CONSTRUCTION TRAFFIC MANAGEMENT PLAN

Sydney Metro West – Western Tunnelling Package

James Ruse Drive Barrier Installation, Rosehill

Document Reference #: **SMWSTWTP-GLO-RSH-TF-PLN-000001**

Figure 5 - Temporary safety barrier design

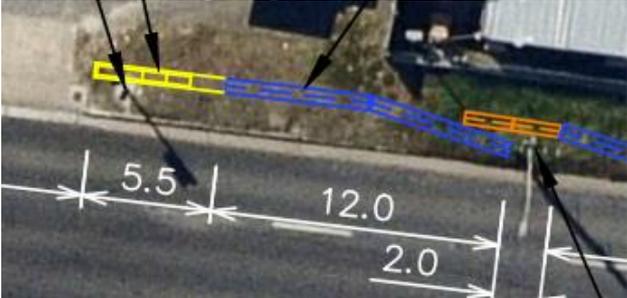
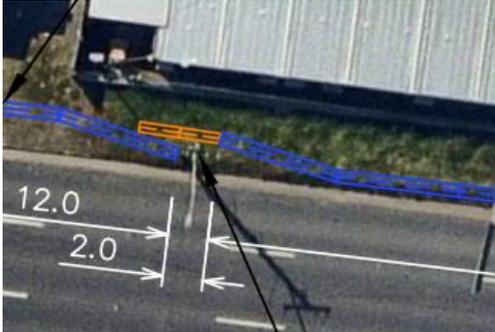
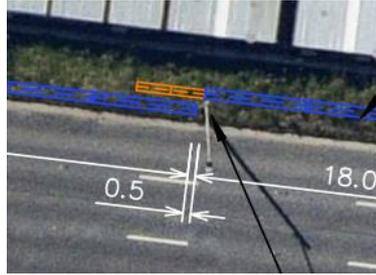
Figure 5 – Temporary Safety Barrier Design shows ABSORB M terminal been installed. Austroads Safety Barrier Technical Conditions for Use states as a system condition that a 18.5m x 6m that a clear run-out area is required. It noted during the onsite inspection the existing barriers installed at compound area are not protected with an appropriate end terminal. Installation of end terminals outside of manufacturers specification and not inline with acceptance documents may see the severity on an incident increase if it was to occur.

2	Design Report -SMWSTWTP-GLO- CLJ-TF-PLN-	Table 4 Barrier design statement outlines design variations that include an increased dynamic deflection with barrier lengths less than that setout in Austroads Safety Barrier Technical Conditions for Use. It is unclear how this adjustment was completed and no risk assessment attached for changes to barrier dynamic deflection.	Noted. Table 4 updated to include assessment from Austroads Technical Advice SBTA 23-003 (Working Width for Lower Impact Speeds) <table border="1"> <caption>Table 1: Modification factors for speed-specific working width</caption> <thead> <tr> <th rowspan="2">Barrier Type</th> <th colspan="6">Operating Speed (km/h)</th> </tr> <tr> <th>100</th> <th>90</th> <th>80</th> <th>70</th> <th>60</th> <th>50</th> </tr> </thead> <tbody> <tr> <td>Post and Rail Systems</td> <td>-</td> <td>-</td> <td>0.8</td> <td>0.7</td> <td>0.6</td> <td>0.5</td> </tr> <tr> <td>Temporary Pinned Systems</td> <td>-</td> <td>-</td> <td>0.8</td> <td>0.7</td> <td>0.6</td> <td>0.5</td> </tr> <tr> <td>Temporary Freestanding Systems</td> <td>-</td> <td>-</td> <td>0.8</td> <td>0.85</td> <td>0.5</td> <td>0.35</td> </tr> </tbody> </table> <p>Note: Modification factors based on a 2270 kg vehicle, an impact angle of 25 degrees and an impact speed of 10 km/h more than the posted speed.</p>	Barrier Type	Operating Speed (km/h)						100	90	80	70	60	50	Post and Rail Systems	-	-	0.8	0.7	0.6	0.5	Temporary Pinned Systems	-	-	0.8	0.7	0.6	0.5	Temporary Freestanding Systems	-	-	0.8	0.85	0.5	0.35	30/07/2024

4	Design Report -SMWSTWTP-GLO- CLJ-TF-PLN-	The above situation is repeated at the start of the initial barrier run.	As above	30/07/2024																																		
5	Design Report -SMWSTWTP-GLO- CLJ-TF-PLN-	Figure 5 – Temporary Safety Barrier Design shows ABSORB M terminal been installed. Austroads Safety Barrier Technical Conditions for Use states as a system condition installation on top of a kerb is not recommended. Installation of end terminals outside of manufacturer's specification and not inline with acceptance documents may see the severity on an incident increase if it was to occur.	Noted.	30/07/2024																																		
6	Design Report -SMWSTWTP-GLO- CLJ-TF-PLN-	Figure 5 – Temporary Safety Barrier Design shows ABSORB M terminal been installed. Austroads Safety Barrier Technical Conditions for Use states as a system condition that a 18.5m x 6m clear run-out area is required. It is noted during the onsite inspection the existing barriers installed at compound area are not protected with an appropriate end terminal. Installation of end terminals outside of manufacturer's specification and not inline with acceptance documents may see the severity on an incident increase if it was to occur.	Noted. Clear run out areas are not possible due to existing site constraints. Area at start of barriers will be clear of any hazards. As per Austroads SBTA 21-003 (table 1 below) a crash cushion run out area at 70km/h is not required. <table border="1"> <caption>Table 1: Recommended run-out area by terminal type</caption> <thead> <tr> <th>Terminal type</th> <th>Run-out area at 100 km/h</th> <th>Run-out area at 70 km/h</th> </tr> </thead> <tbody> <tr> <td>Guardrail terminal</td> <td>18.5 m x 6 m from PoR</td> <td></td> </tr> <tr> <td>Crash cushion</td> <td>8 m x 12 m from nose</td> <td>Not required</td> </tr> <tr> <td>Wire Rope Safety Barrier</td> <td>18.5 m x 6 m from PoR</td> <td></td> </tr> <tr> <td>Plastic water filled terminal</td> <td>18.5 m x 6 m from nose</td> <td>10 m x 6m from PoR</td> </tr> </tbody> </table>	Terminal type	Run-out area at 100 km/h	Run-out area at 70 km/h	Guardrail terminal	18.5 m x 6 m from PoR		Crash cushion	8 m x 12 m from nose	Not required	Wire Rope Safety Barrier	18.5 m x 6 m from PoR		Plastic water filled terminal	18.5 m x 6 m from nose	10 m x 6m from PoR	30/07/2024

10/09/2024	GLC		SMWSTWTP-GLO-RSH-TF-PLN-000001	Table 4, Figure 5	SM-W-WTP-GS-688	TCAWS 6.2.3 "Use of temporary safety barriers on kerbs" further states that barriers should be greater than 1.5m behind kerb or within 0.2m of kerb to assist in preventing pitch and/or roll. Barrier design has also been done by an experienced road designer.	Potential Non-Compliance		N

TGS Name & Number:	LGP - 111691 - GLC 192 - James Ruse Dr Rosehill
Works Location:	29 James Ruse Drive, Rosehill (Racecourse Carpark)
Project Name:	Sydney Metro Western Tunneling
Project Description:	Kerb Side Barrier Installation

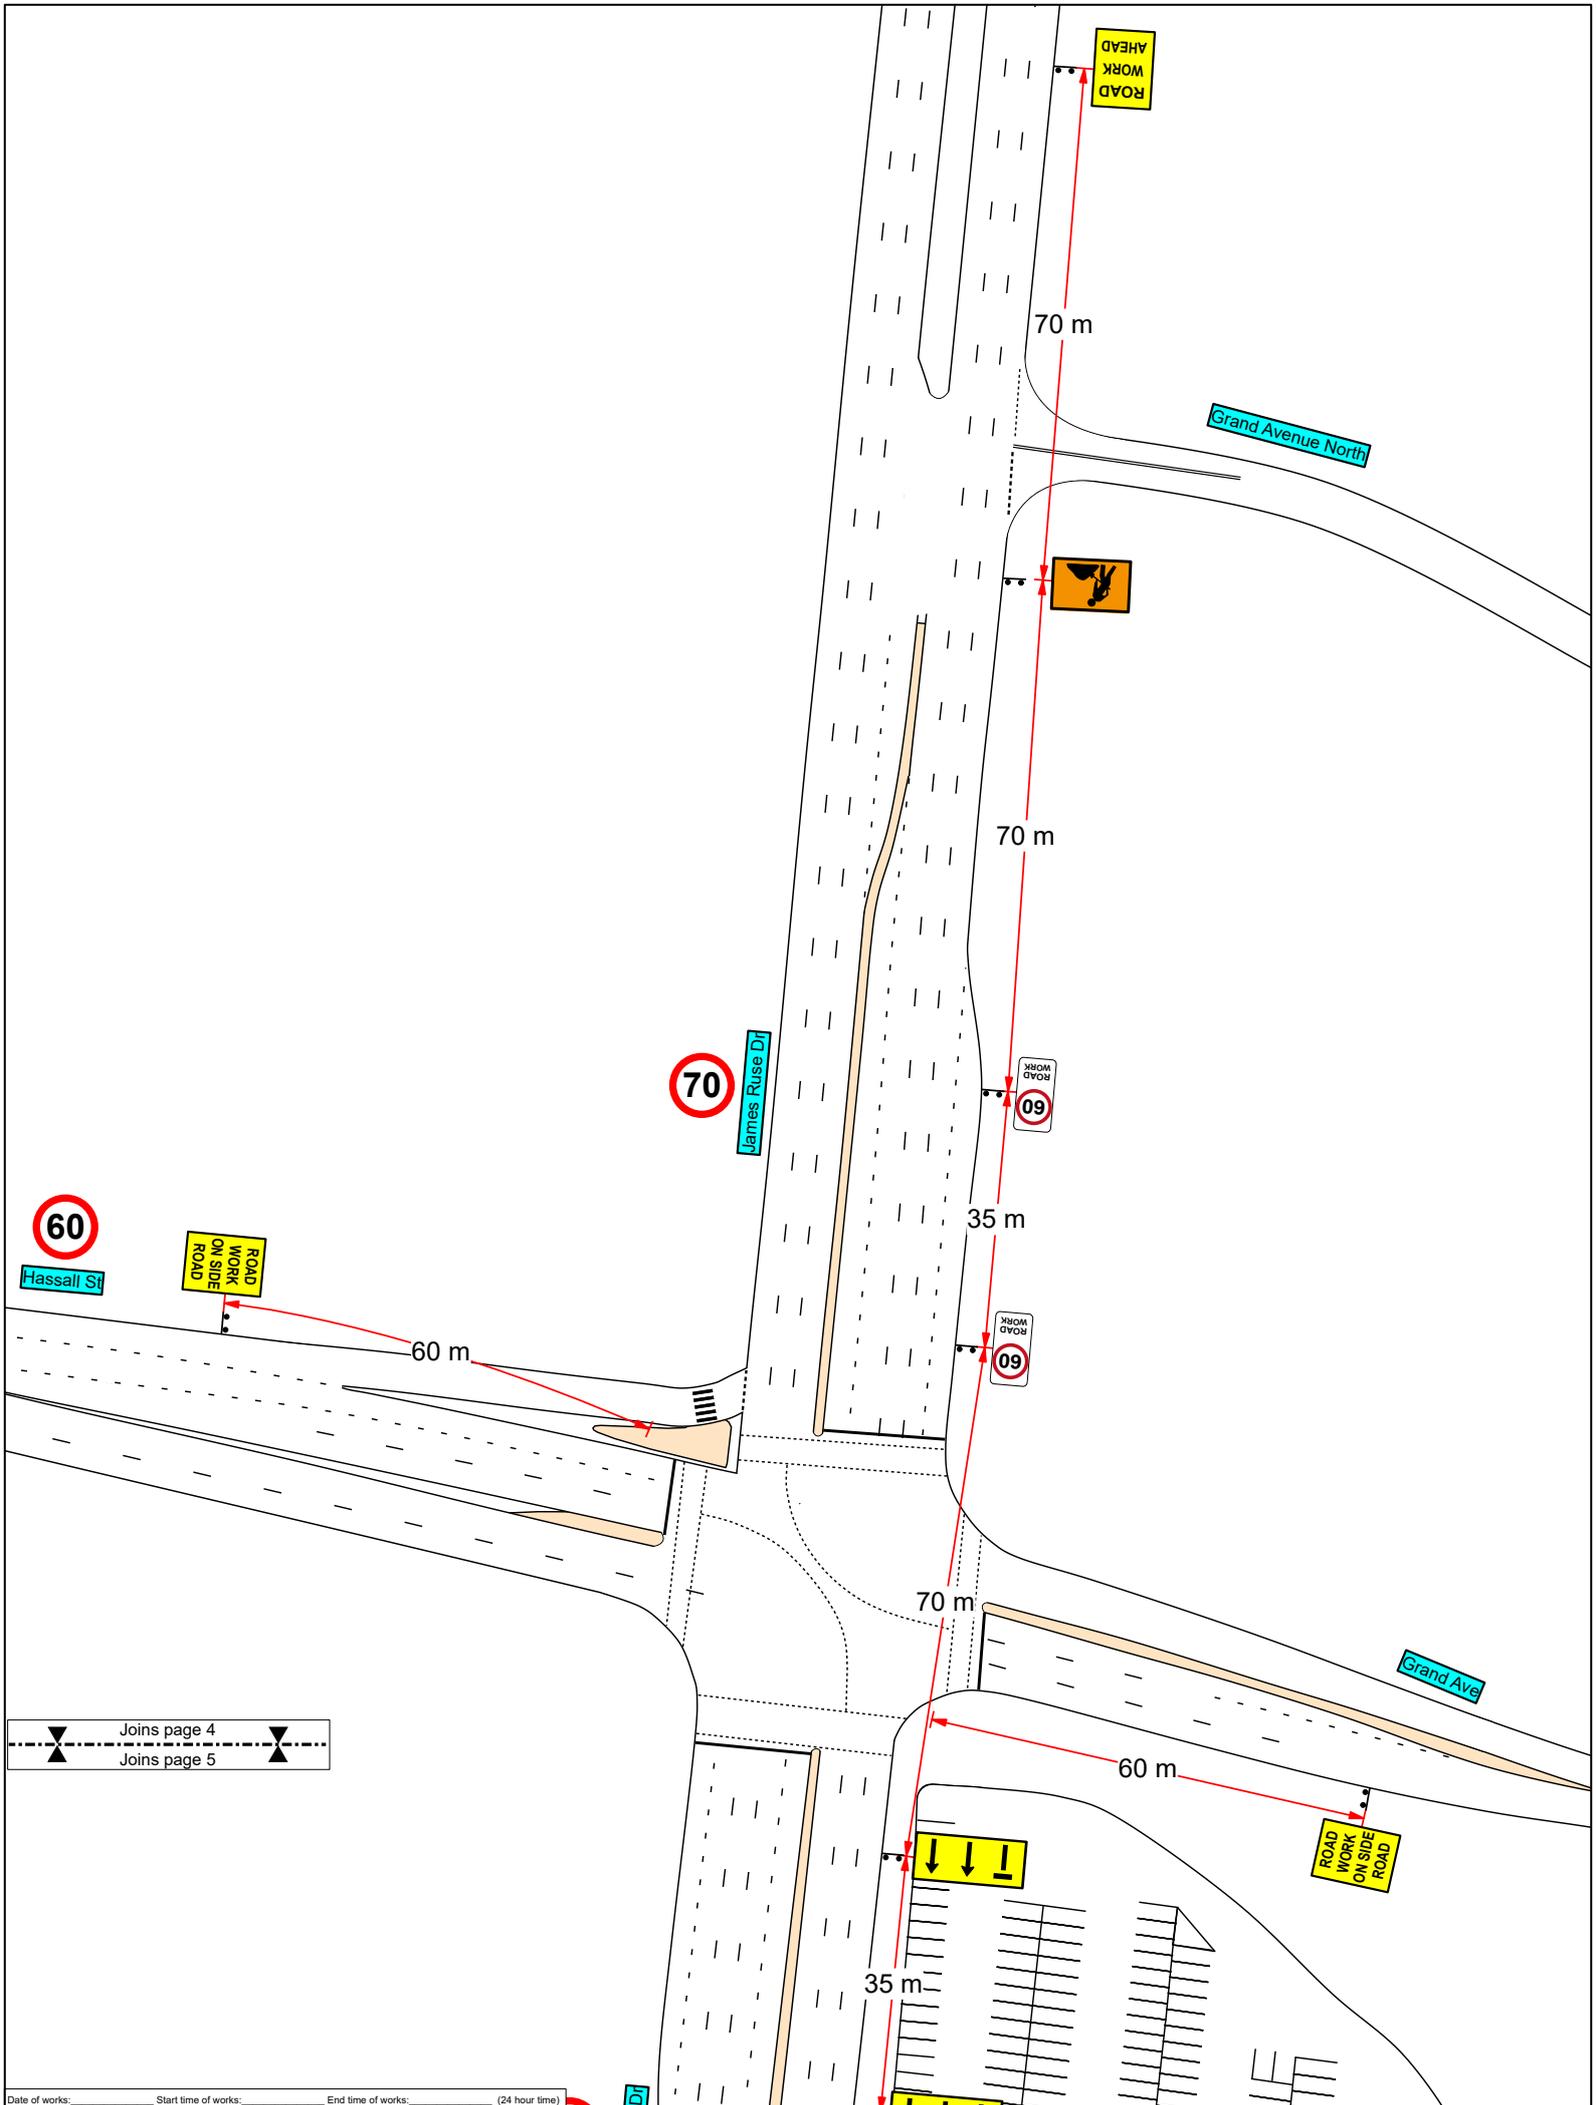
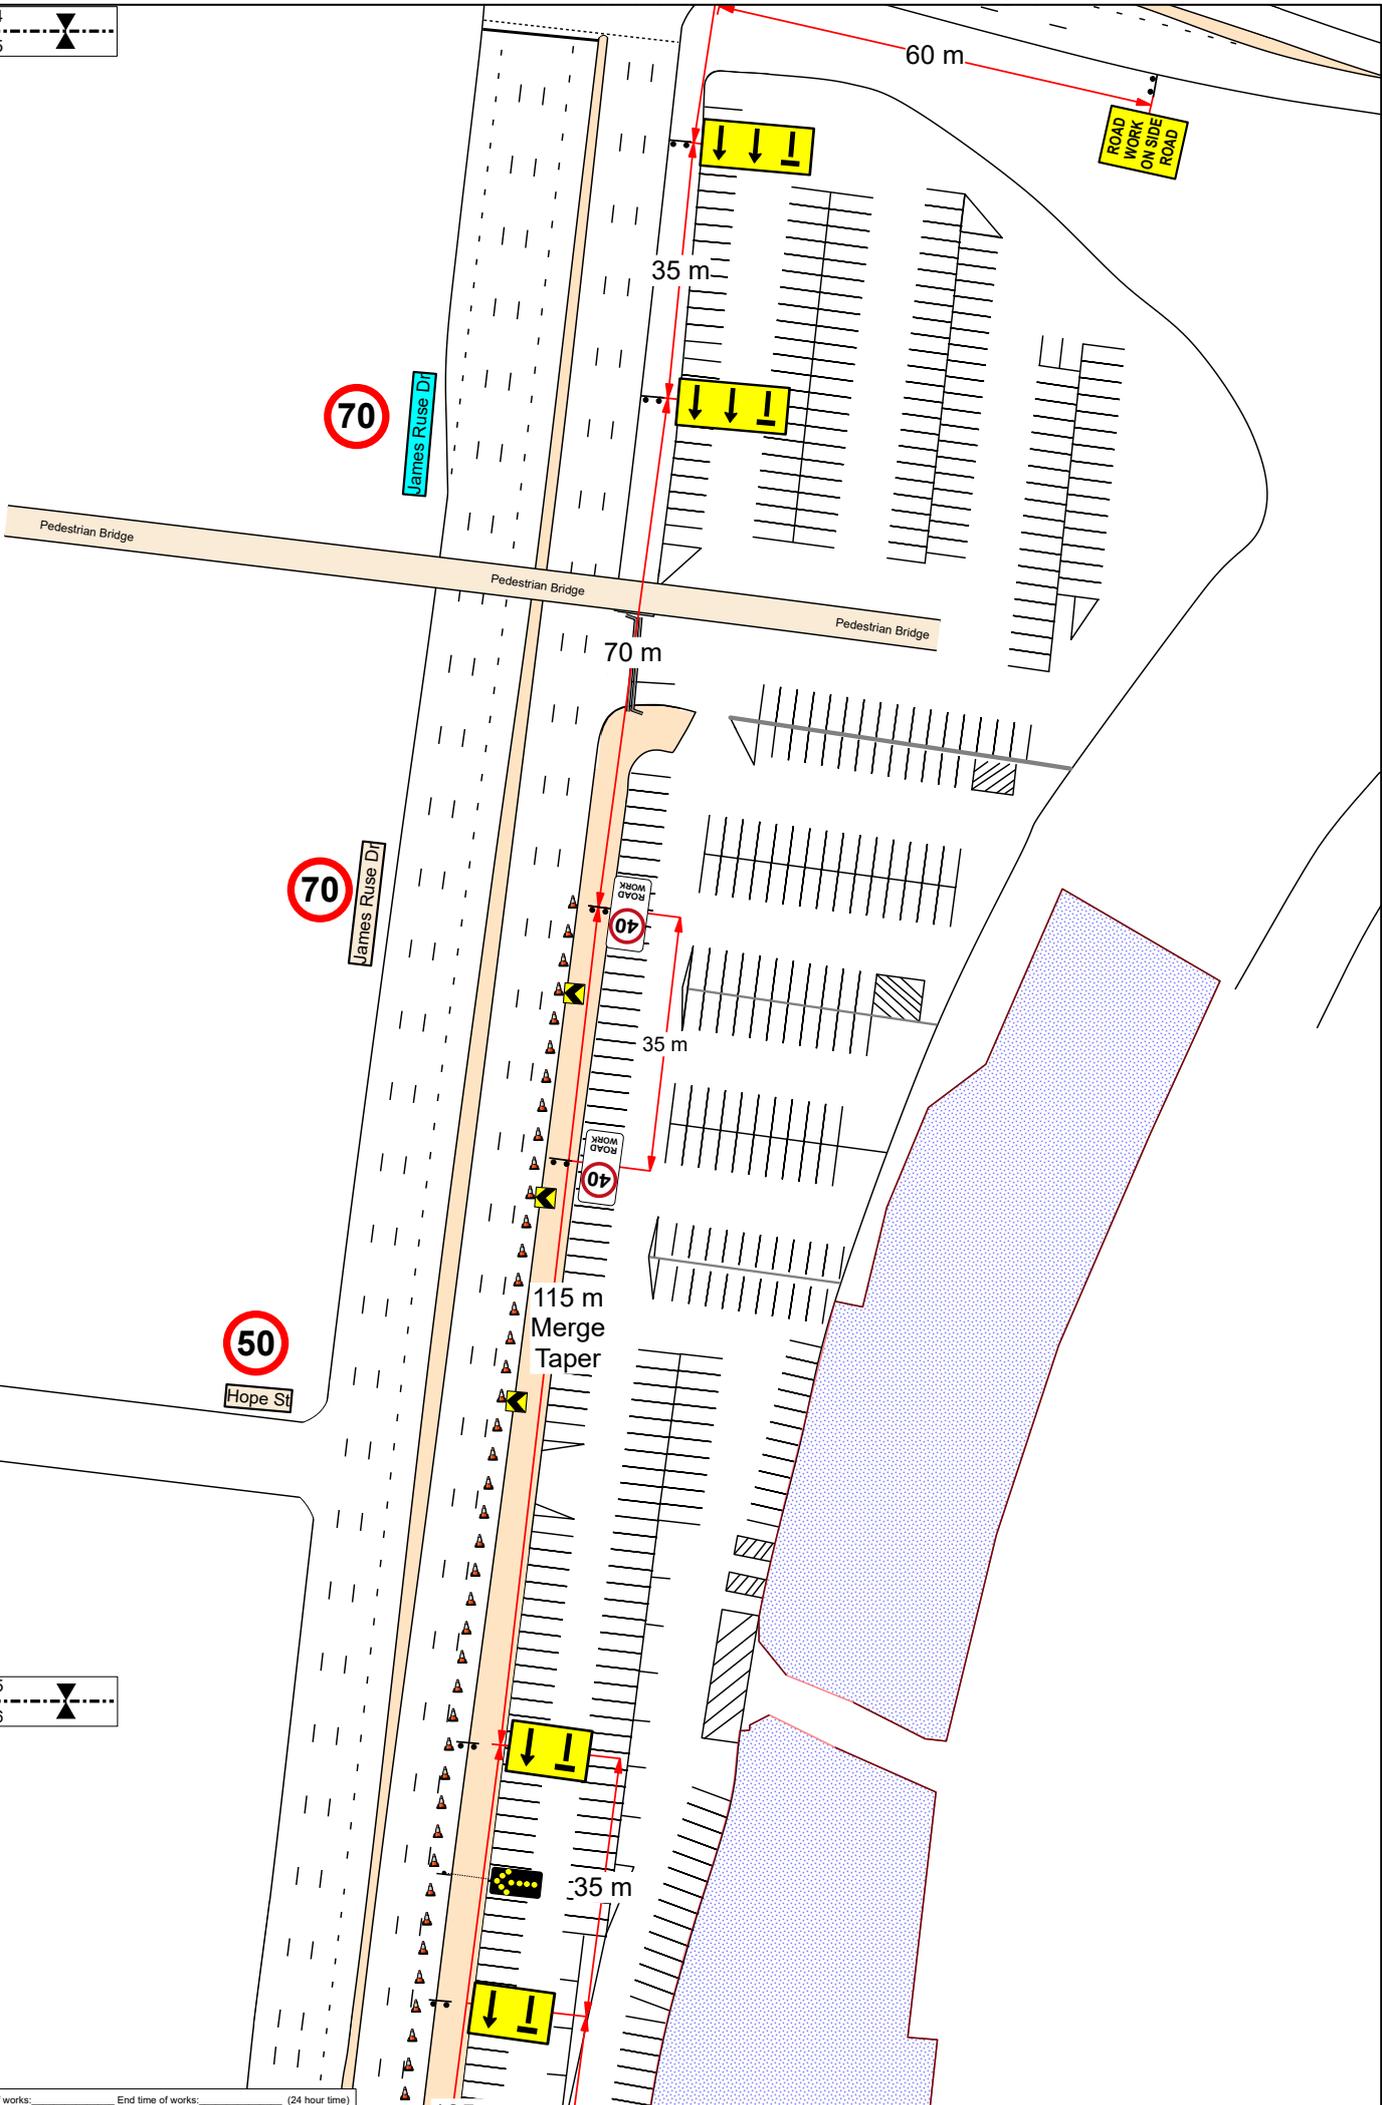
CONTRACT NO.	DOCUMENT NO.	TITLE	VER	STATUS	NO.	DATE	COMPANY	RAISED BY	REVIEW DOC. NO.	DOCUMENT REF	DEED REF	COMMENTS / RESPONSE	COMMENT CATEGORY	LINKED ITEM NO	CLOSED OUT
WTP	SMWSTWTP-GLO-RSH-TF-PLN-000001	Sydney Metro West - WTP - Construction Traffic Management Plan - James Ruse Drive Barrier Installation, Rosehill	A.01	S3	01	3/09/2024	SKB	[REDACTED]	SMWSTWTP-GLO-RSH-TF-PLN-000001	Appendix 1 - LGP-111691-GLC192-James Ruse Dr (Page 5 of 6)	SM-W-WTP-PS-2647	The requirement SM-W-WTP-PS-2647 states "The Tunnelling Contractor must ensure road works including geometry, pavement, barriers, cycle lanes, kerbs and gutters, footpaths, markings, signage and traffic controls, and layout design comply with the relevant Authorities standards, specifications and guidelines, including: Austroads (internal and external roads)" and has not been met. The indication of traffic cone is missing on TGS Appendix 1 - LGP-111691-GLC192-James Ruse Dr (Page 5 of 6).	Actual Non-Compliance		N
